MACARTHUR TRANSIT VILLAGE

SEPTEMBER 28, 2016

ORIGINAL FDP (& DRC) GROUND FLOOR PLAN

PROPOSED GROUND FLOOR PLAN

ORIGINAL FDP (& DRC)

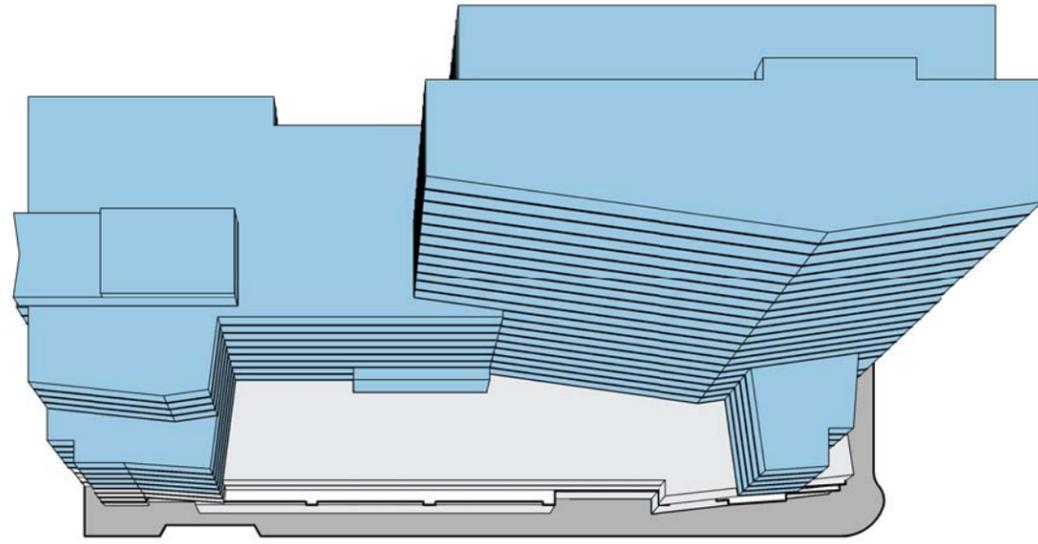
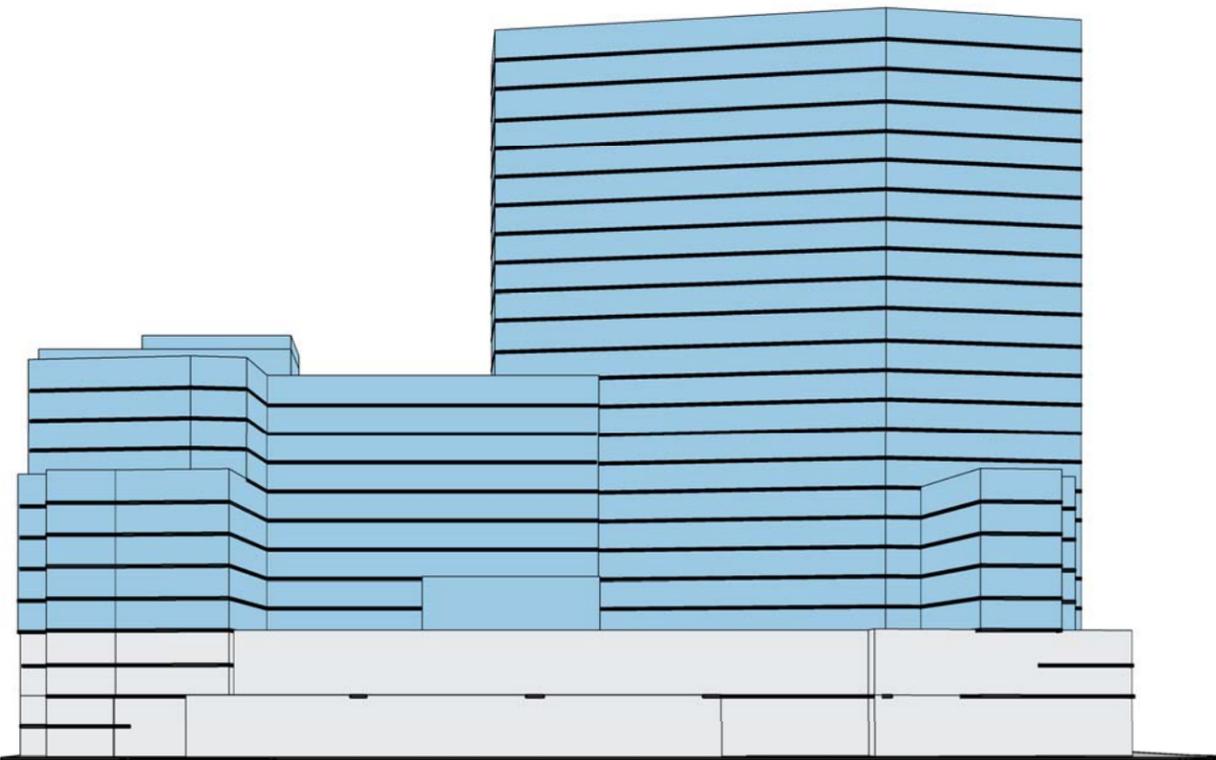
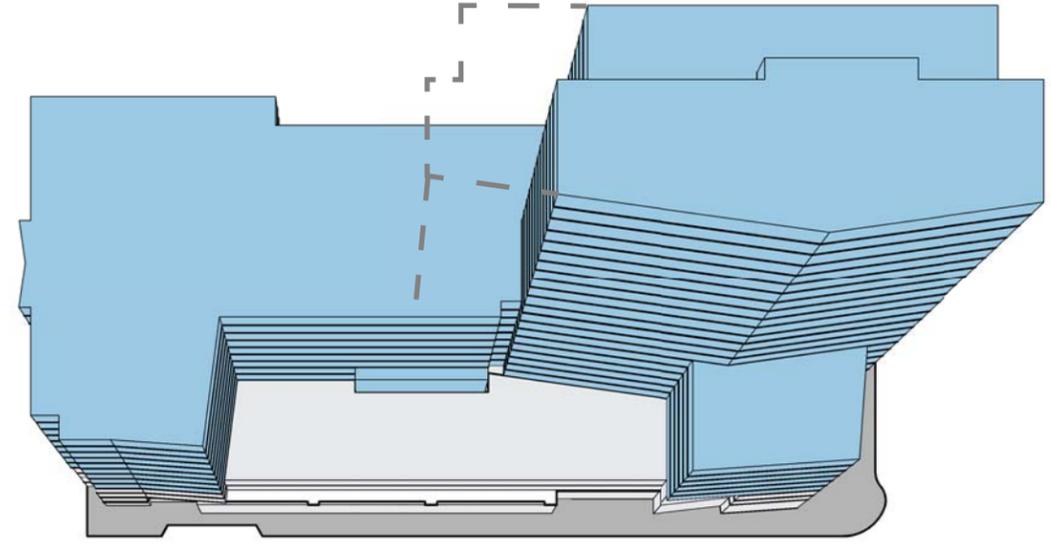
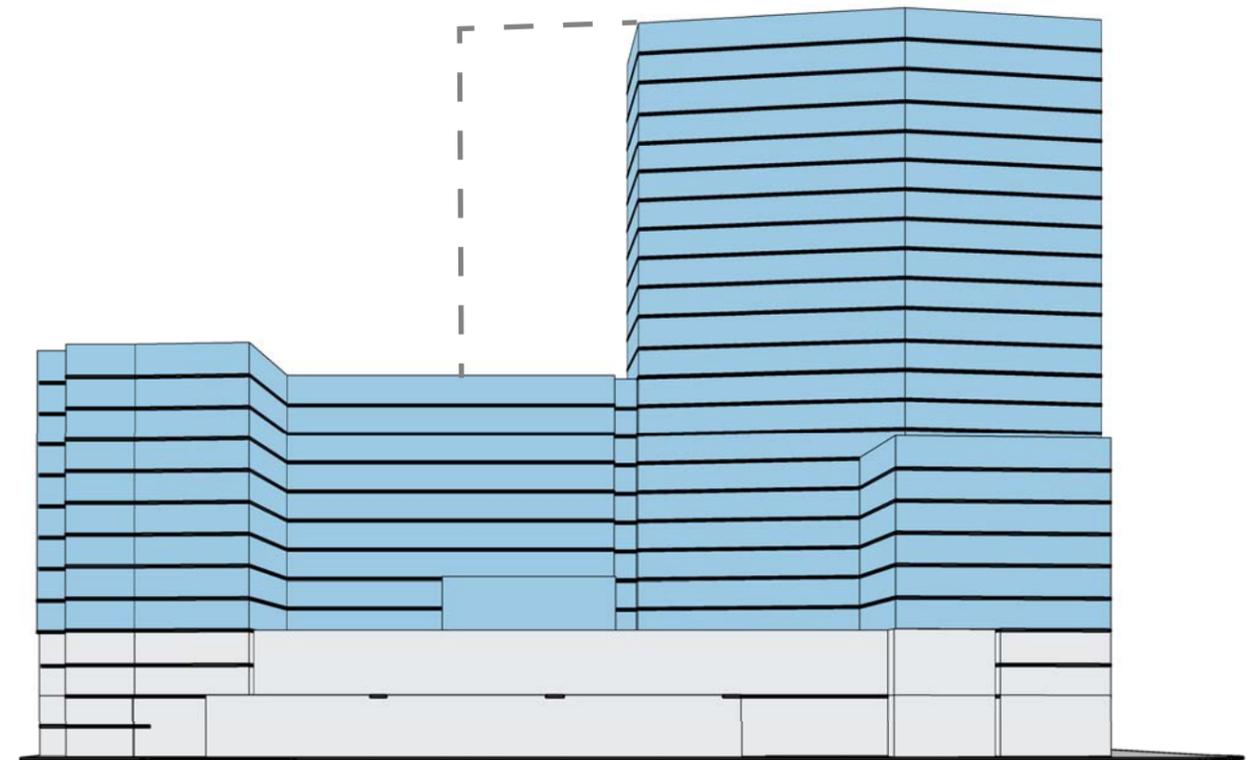
TOWER LENGTH REDUCED BY 40' FROM 192' TO 152'
TOWER FLOORPLATE REDUCED FROM 12,500SF TO APPROX 10,000SF
SOME AREA REDUCTION BY STANDARISING UNIT MIX.
RESIDUAL TOWER VOLUME REDISTRIBUTED TO PODIUM WINGS
PODIUM PULLED BACK AT WALTER MILES WAY TO CREATE SIDEWALK

ORIGINAL FDP (& DRC)

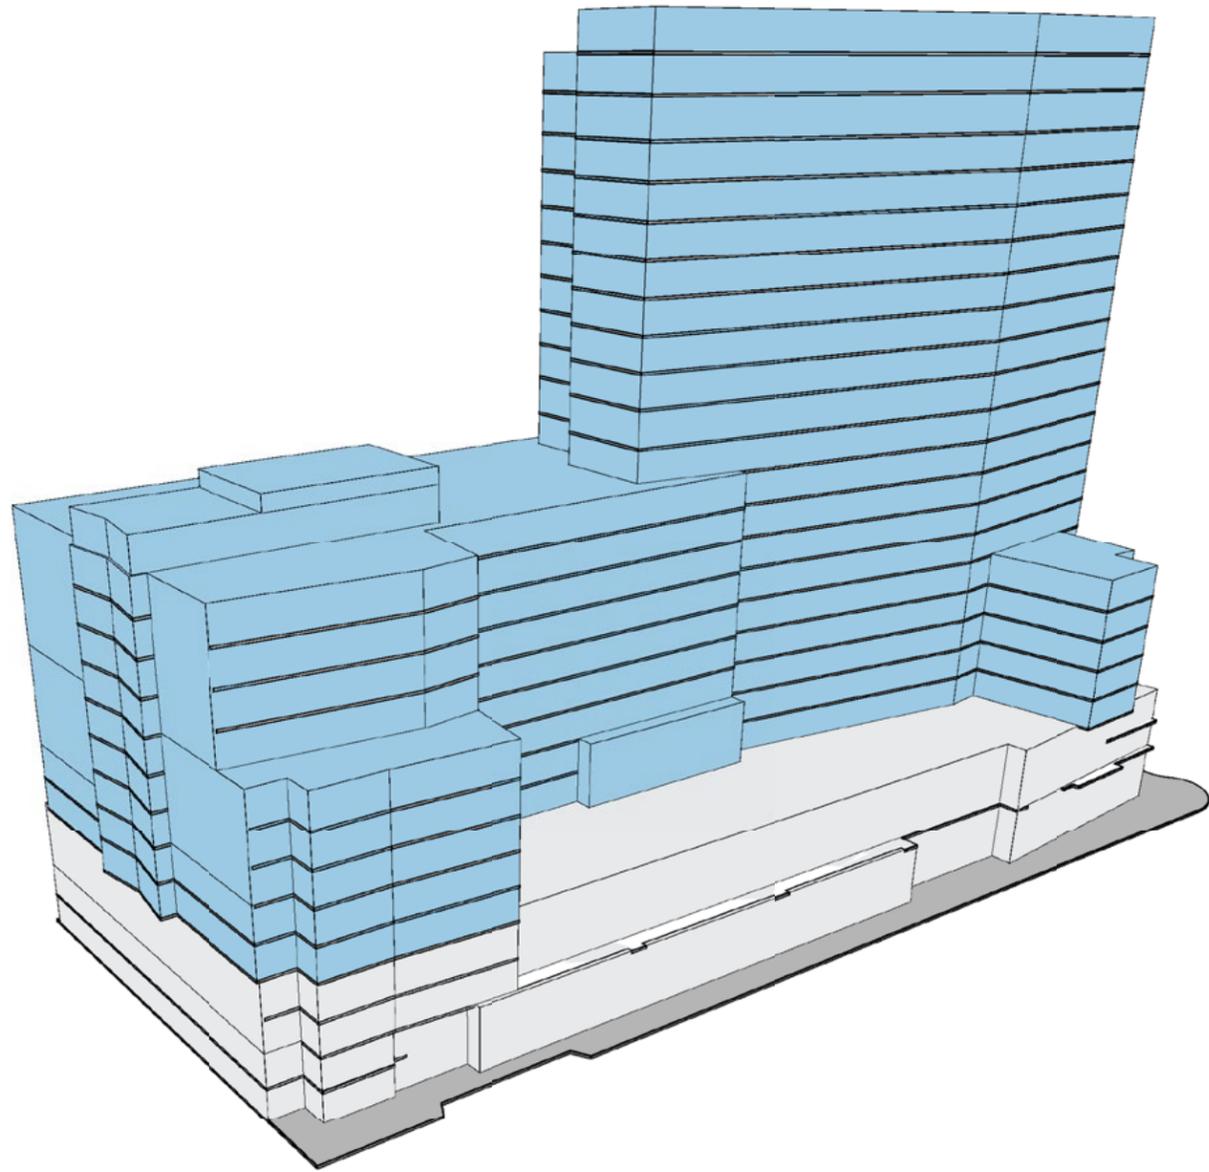
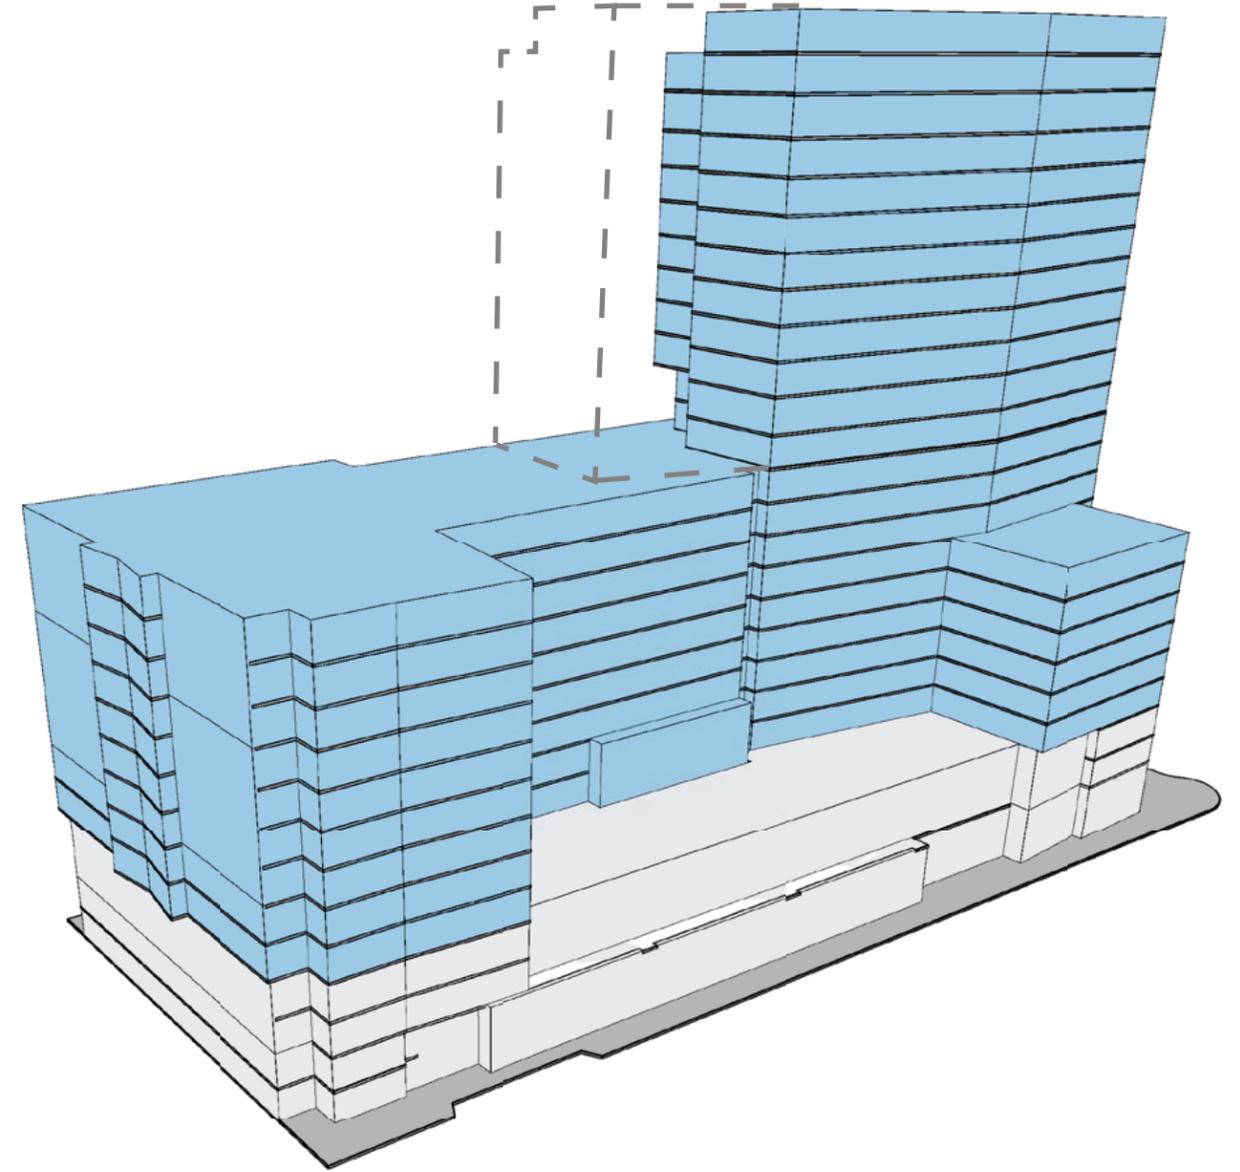
TOWER LENGTH REDUCED BY 40' FROM 192' TO 152'
TOWER FLOORPLATE REDUCED FROM 12,500SF TO APPROX 10,000SF
SOME AREA REDUCTION BY STANDARDISING UNIT MIX.
RESIDUAL TOWER VOLUME REDISTRIBUTED TO PODIUM WINGS
PODIUM PULLED BACK AT WALTER MILES WAY TO CREATE SIDEWALK

ORIGINAL FDP (& DRC)

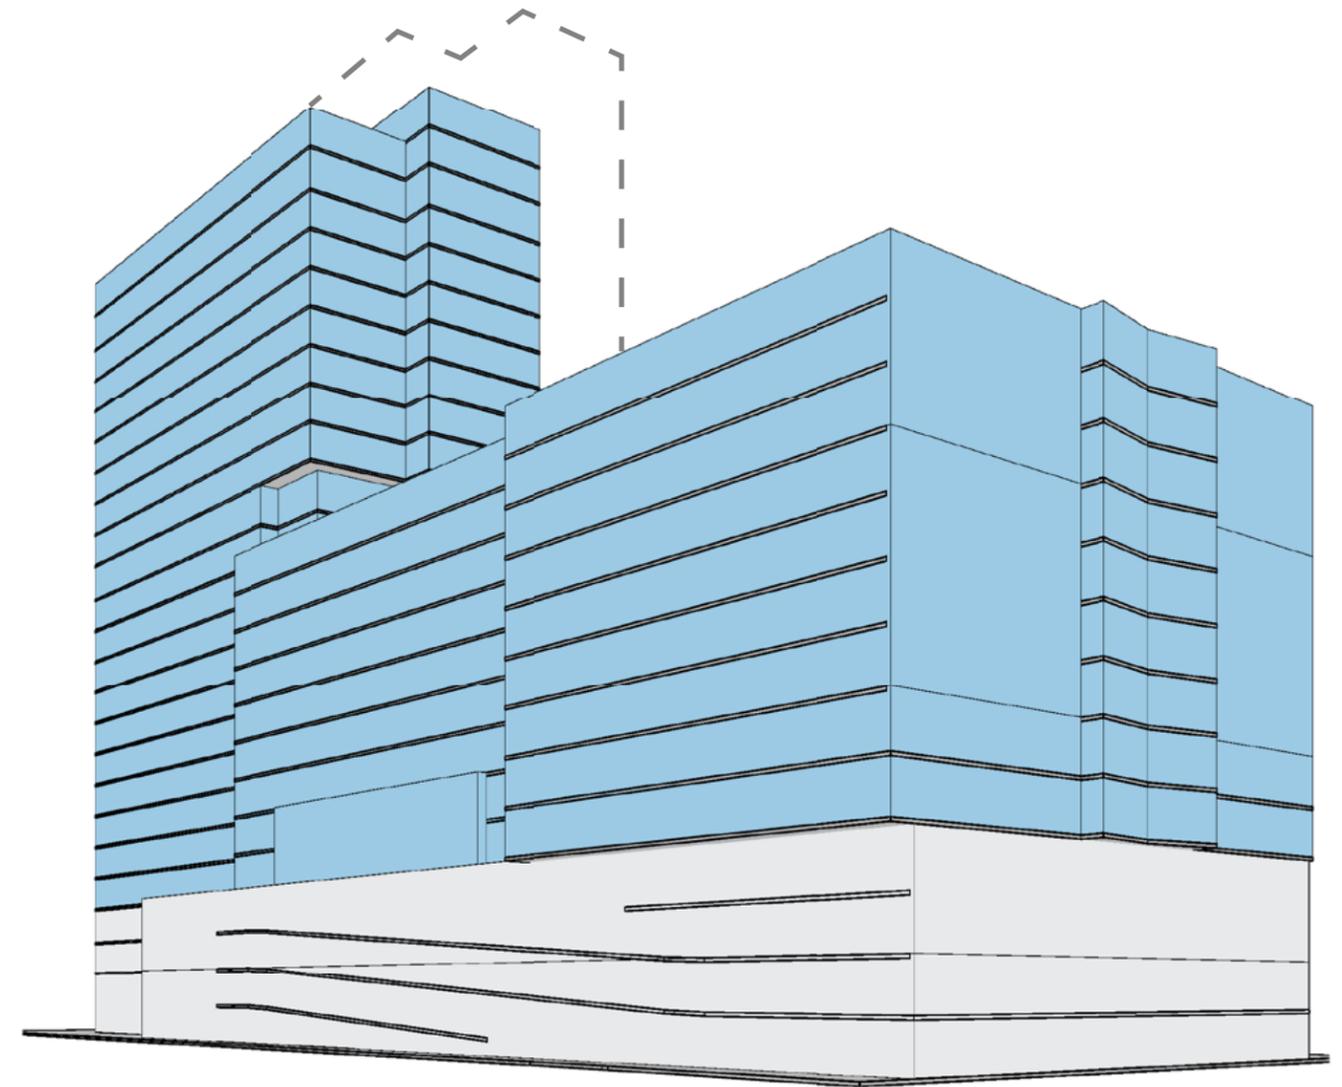
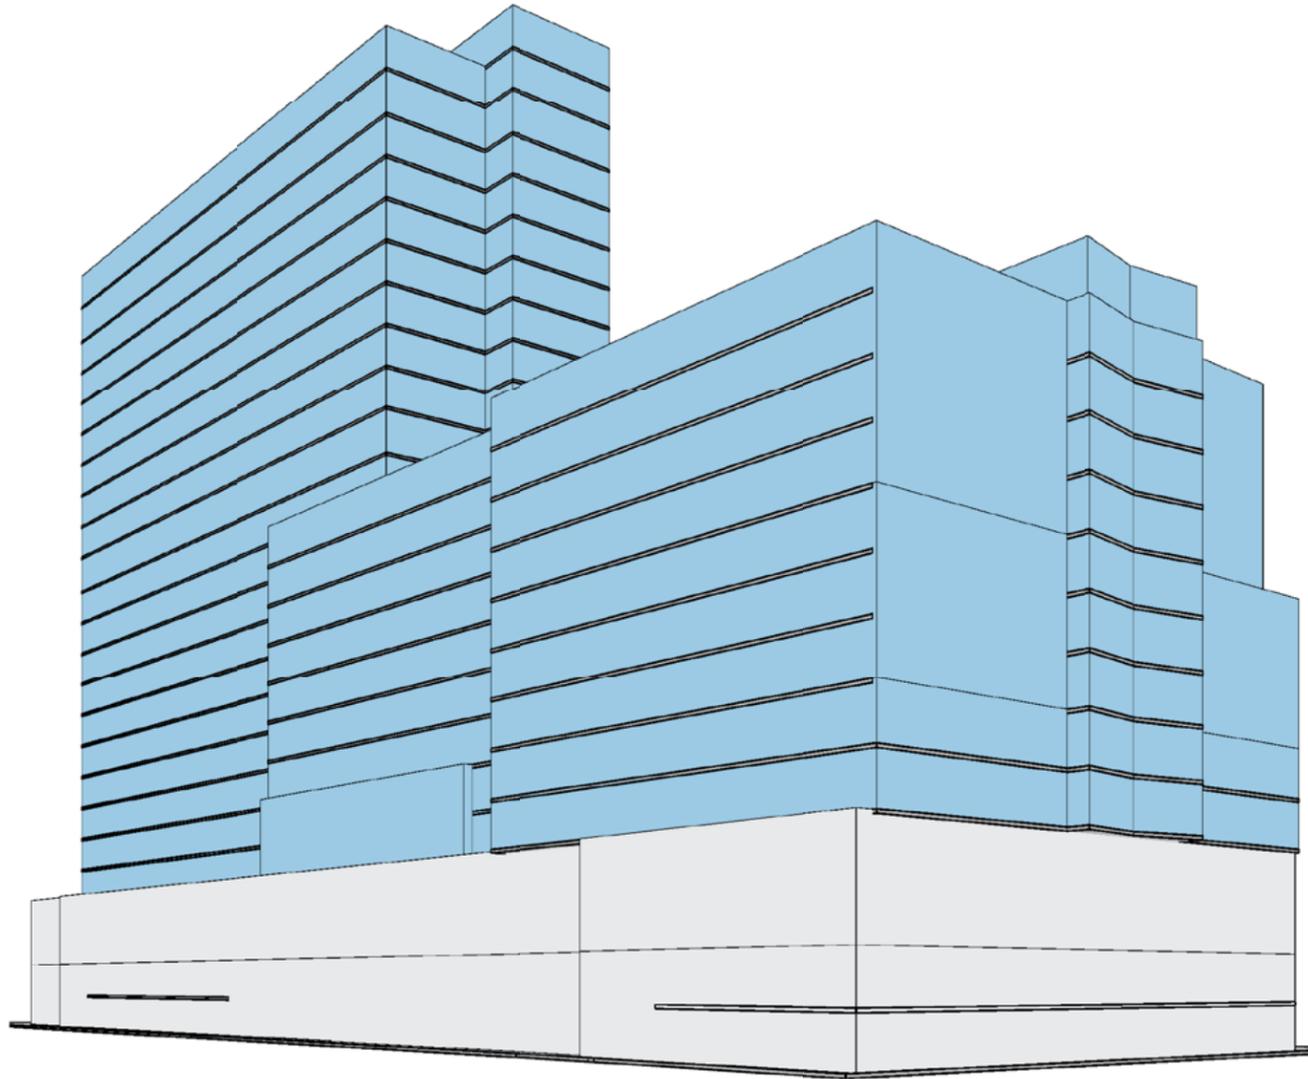
TOWER LENGTH REDUCED BY 40' FROM 192' TO 152'
TOWER FLOORPLATE REDUCED FROM 12,500SF TO APPROX 10,000SF
SOME AREA REDUCTION BY STANDARDISING UNIT MIX.
RESIDUAL TOWER VOLUME REDUCTION REDISTRIBUTED TO PODIUM WINGS
PODIUM PULLED BACK AT WALTER MILES WAY TO CREATE SIDEWALK
